**This WP is an update to WP424 and contains Attachments
presenting the proposed resolution of two of the problems
originally described.**

AERONAUTICAL TELECOMMUNICATIONS NETWORK PANEL

ATN Internet Working Group (WG2)

Issues Arising from Further ICS Validation

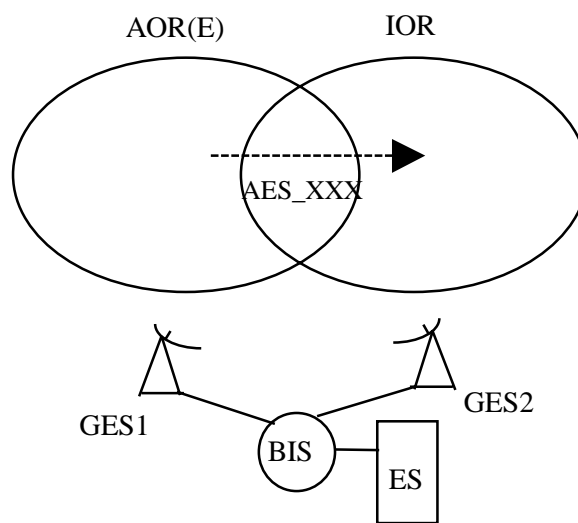
4.2 The situation arises thus (see diagram on next page):

1. An aircraft has a connection via AOR(E) and GES1 to the Ground BIS Router. The BIS Route table may be represented as:

2. The aircraft moves into the IOR coverage and, having lost the GES1 connection, establishes a new route via IOR and GES2. The Ground BIS Route table is updated to become:

Data is sent from the AES via link 2. Any response data sent via the first route available (i.e. via GES1) cannot be forwarded to the AES as the connection has been lost between the AES and GES1. However, the connection between GES1 and Air/Ground BIS has not been cleared and the route continues to exist.

2. WG2 should consider whether the ATN SARPs should indicate that where two circuits exist the Ground Router should always use the most recently defined route (ISH) that was received.
